# Office Action Summary

10/500,796

CHANG, GWONG-JEN J

### **Detailed Office Action**

Fig. 2

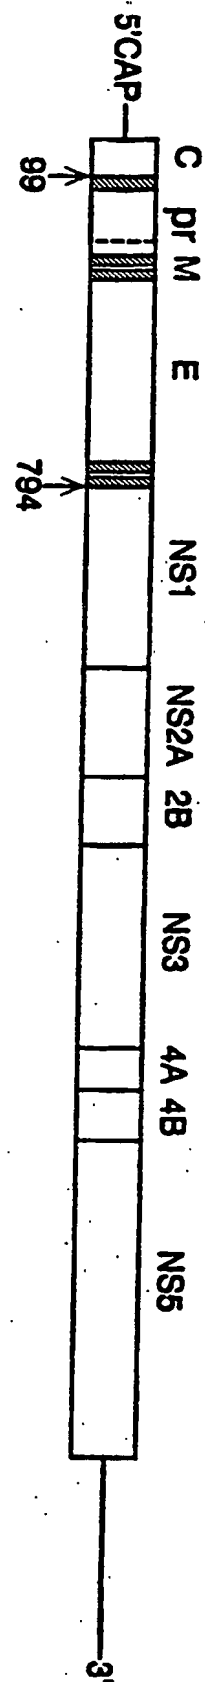
This application contains sequence disclosures that are encompassed by the definitions for nucleotide and/or amino acid sequences set forth in 37 C.F.R. § 1.821(a)(1) and (a)(2) (e.g., see Figure 2). However, this application fails to comply with the requirements of 37 C.F.R. § 1.821 through 1.825 for the reason(s) set forth below or on the attached Notice To Comply With Requirements For Patent Applications Containing Nucleotide Sequence And/Or Amino Acid Sequence Disclosures. Applicants are reminded that sequences appearing in the specification and/or **drawings** must be identified by a sequence identifier (SEQ ID NO. :) in accordance with 37 C.F.R. § 1.821(d). Applicant must provide appropriate amendments to the specification and/or drawings inserting the required sequence identifiers. Extensive amendments may necessitate the submission of a substitute specification. If sequence identifiers have already been provided for p14DV389 and p14DV2453, applicants may simply amend the figure descriptions to reference those relevant portions of the sequence identifiers (e.g., nucleotides 1-49 of SEQ ID NO.: X).

The drawings are objected to because they fail to comply with 37 C.F.R. § 1.821-1.825 (see Figure 2). Applicants are reminded that sequences appearing in the specification and/or drawings must be identified by a sequence identifier (SEQ ID NO. :) in accordance with 37 C.F.R. § 1.821(d). Applicant must provide appropriate amendments to the specification and/or drawings

inserting the required sequence identifiers. Extensive amendments may necessitate the submission of a substitute specification. If sequence identifiers have already been provided for p14DV389 and pc14DV2453, applicants may simply amend the figure descriptions to reference those relevant portions of the sequence identifiers (e.g., nucleotides 1-49 of SEQ ID NO.: X). Corrected drawing sheets in compliance with 37 C.F.R. § 1.121(d) may be required in reply to the Office action to avoid abandonment of the application. Any amended replacement drawing sheet should include all of the figures appearing on the immediate prior version of the sheet, even if only one figure is being amended. The figure or figure number of an amended drawing should not be labeled as "amended." If a drawing figure is to be canceled, the appropriate figure must be removed from the replacement sheet, and where necessary, the remaining figures must be renumbered and appropriate changes made to the brief description of the several views of the drawings for consistency. Additional replacement sheets may be necessary to show the renumbering of the remaining figures. Each drawing sheet submitted after the filing date of an application must be labeled in the top margin as either "Replacement Sheet" or "New Sheet" pursuant to 37 C.F.R. § 1.121(d). If the changes are not accepted by the examiner, the applicant will be notified and informed of any required corrective action in the next Office action. The objection to the drawings will not be held in abeyance.

- ☒ 7. Other: Applicants are reminded that sequences appearing in the specification and/or **drawings** must be identified by a sequence identifier (SEQ ID NO.:) in accordance with 37 C.F.R. 1.821(d). Sequence identifiers for sequences appearing in the drawings may appear in the Brief Description of the Drawings. Applicant must provide appropriate amendments to the specification and/or drawings inserting the required sequence identifiers. Extensive amendments may necessitate the submission of a substitute specification and drawings.
